Access Compliance Report

Public Rights-of-Way

Intersection ID: 13546	Main Street: N_SHARON_AMITY_RD	Cross Street: TARRYWOOD_LN	Location:	W
ADA ID: E33B66A59430	Ramp Type: Perp	Initial Pass/Fail: Fail	Overall Compliance: No	Severity Score: 30
Codes/Mitigation Info/Possible Solution		Field Measurements/Component Compliance

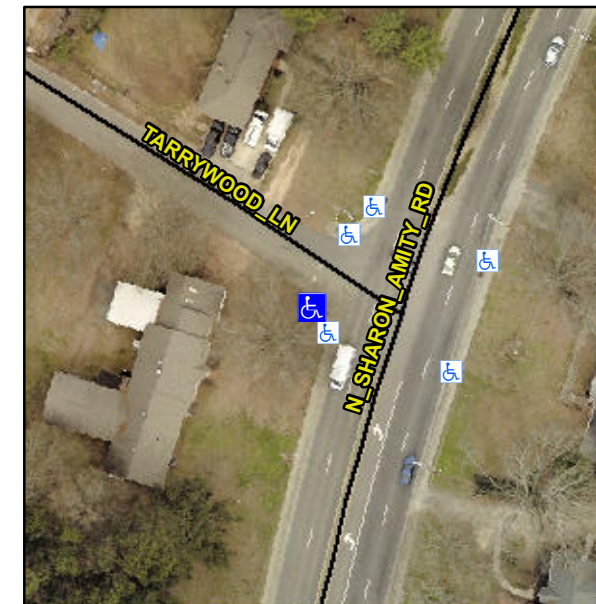
Not Found, R304.5.1, R304.2.2

Compliance	Description	Data	Compliance	Description	Data
N/A	Ramp Length (in)	59.5	No	Ramp Slope (%)	8.7
No	Ramp Width (in)	32.0	Yes	Ramp XSlope (%)	1.6
N/A	Flare Type LT	N/A	N/A	Flare Type RT	N/A
N/A	Flare Slope LT (%)	N/A	N/A	Flare Slope RT (%)	N/A
N/A	Flare Traversable LT?	N/A	N/A	Flare Traversable RT?	N/A
N/A	Landing Length (in)	N/A	N/A	DWS Provided?	N/A
N/A	Landing Width (in)	N/A	N/A	DWS Contrast?	N/A
N/A	Landing Slope (%)	N/A	N/A	DWS Length (in)	N/A
N/A	Landing X Slope (%)	N/A	N/A	DWS Full Width?	N/A
N/A	Landing Curb? (Y/N)	N/A	N/A	DWS Offset (in)	N/A
N/A	Shared Landing?	N/A			
N/A	Gutter Ponding?	Yes	N/A	Gutter Slope (%)	N/A
N/A	Gutter Lip Ht (in)	3.0	N/A	Gutter X Slope (%)	N/A
N/A	Painted X Walk1?	No	N/A	Painted X Walk2?	N/A
	X Walk 1 Direction	To N		X Walk 2 Direction	N/A
N/A	X Walk 1 Width (in)	N/A	N/A	X Walk 2 Width (in)	N/A
	X Walk 1 Slope (%)	3.6		X Walk 2 Slope (%)	N/A
	X Walk 1 X Slope (%)	4.6		X Walk 2 X Slope (%)	N/A

Remove & Replace Entire Ramp.
